RAINFOREST CARWASH & OIL CHANGE

5026 HARDY STREET
HATTIESBURG, MISSISSIPPI 39401

RECEIVED
JUL 22 2013
REC BY: mb

13-2905 5026 Hardy Street

CARWASH FOUNDATION DETAILS

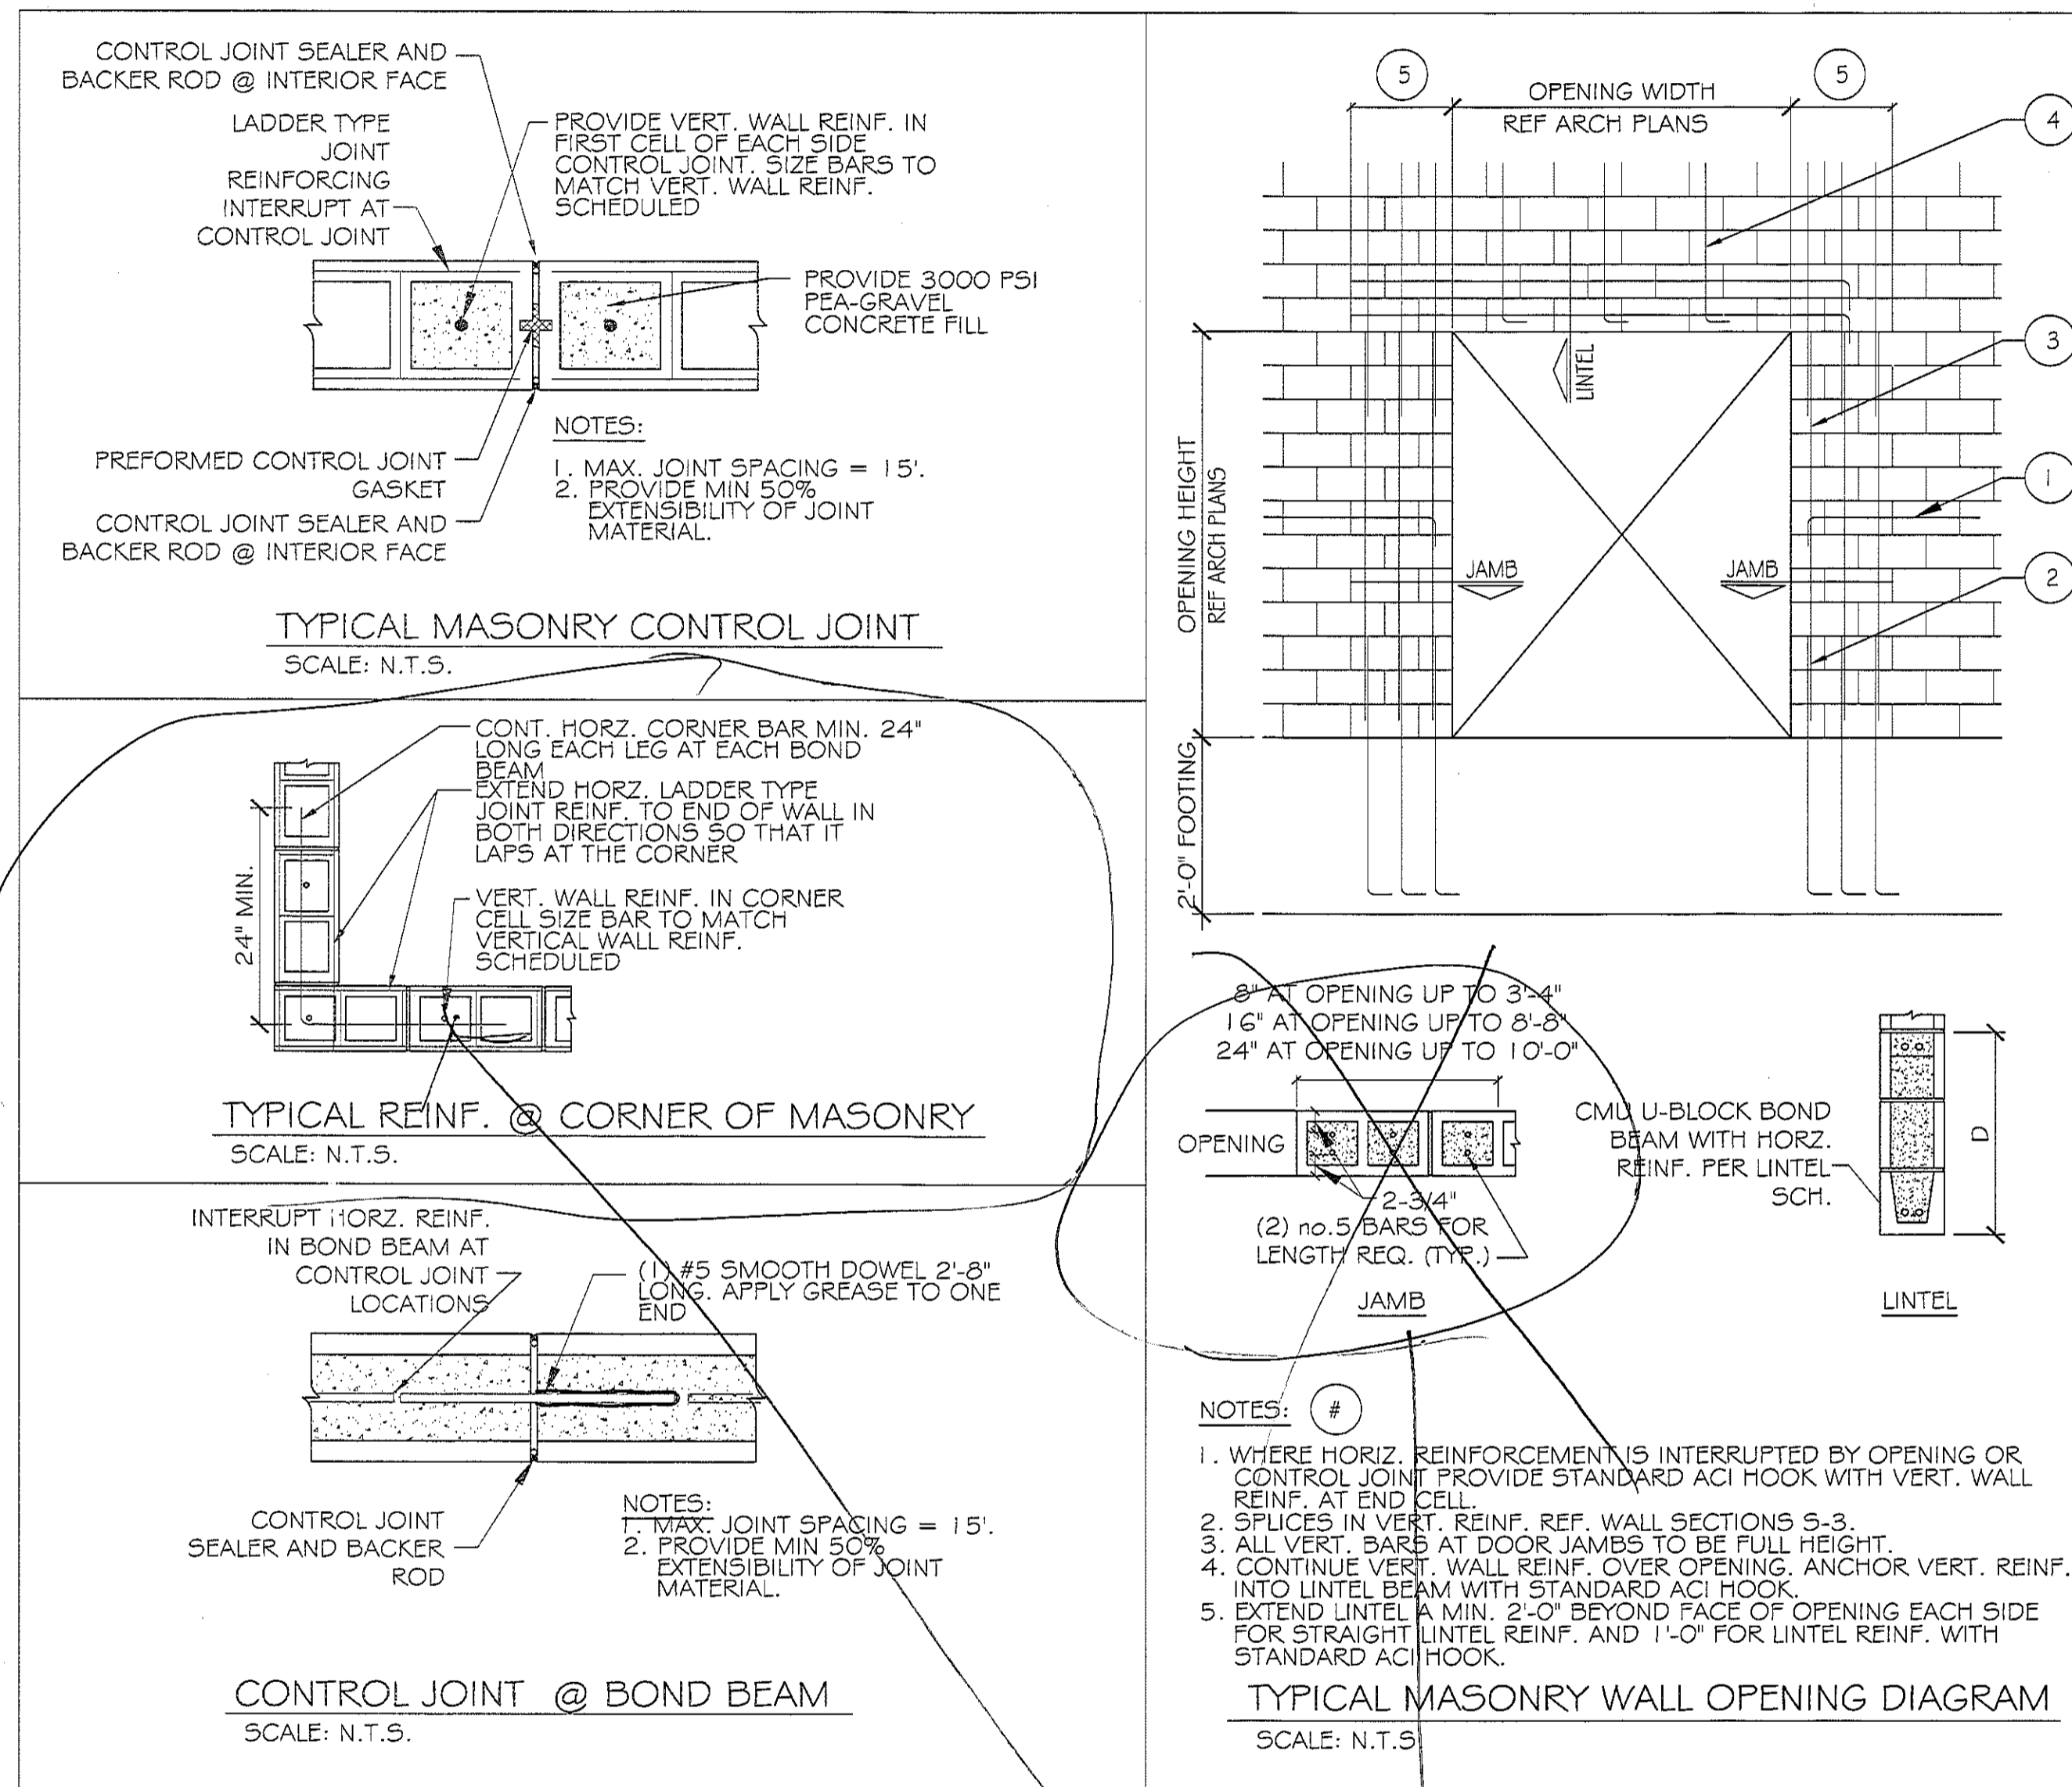
Field Verify Vertical reinforcing & Concrete fill

Engineer cert. required for structural masonry walls per IBC 1704.5

CARWASH POWER & LIGHTING PLAN
SCALE: 3/16" = 1'-0"

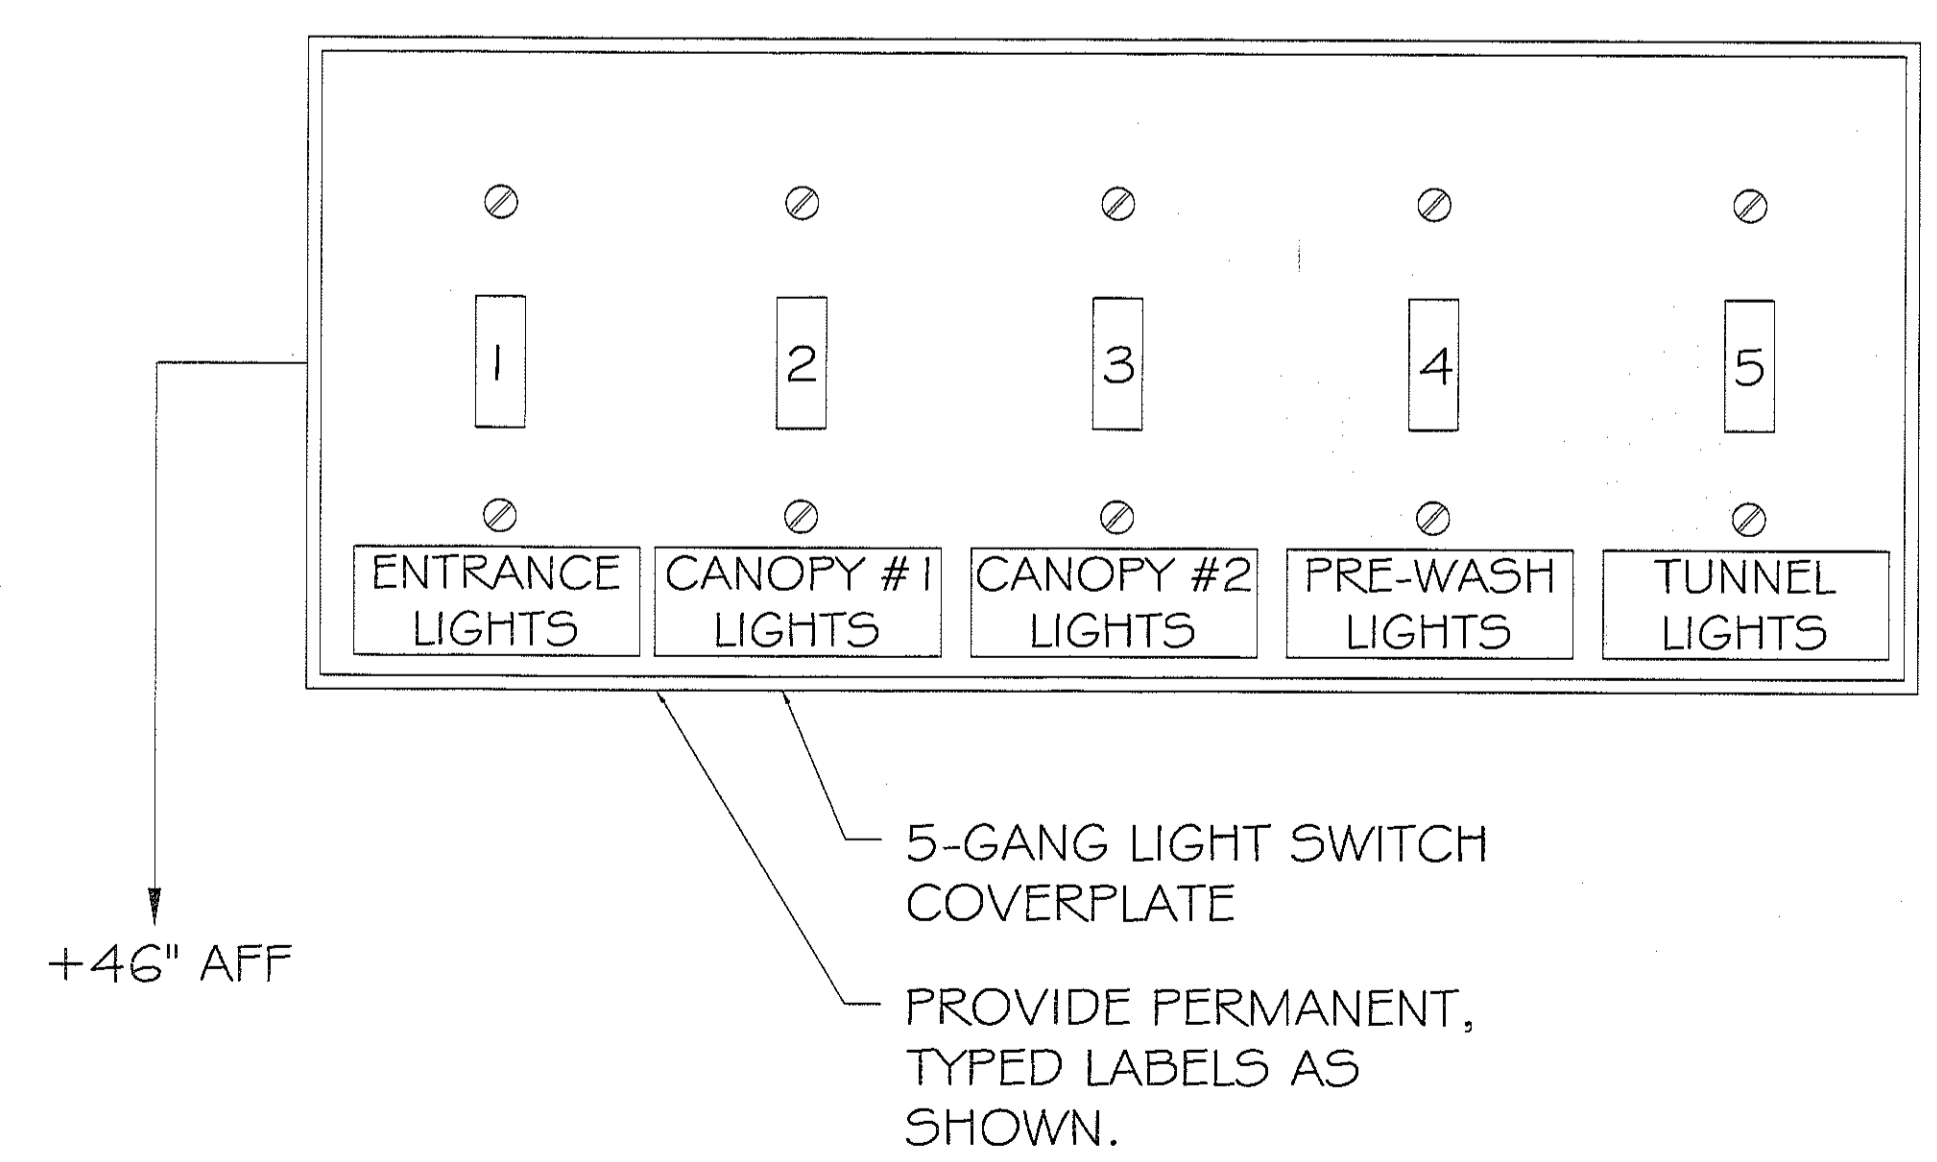
Emergency lights @ exterior landings IBC 1006.3 #5
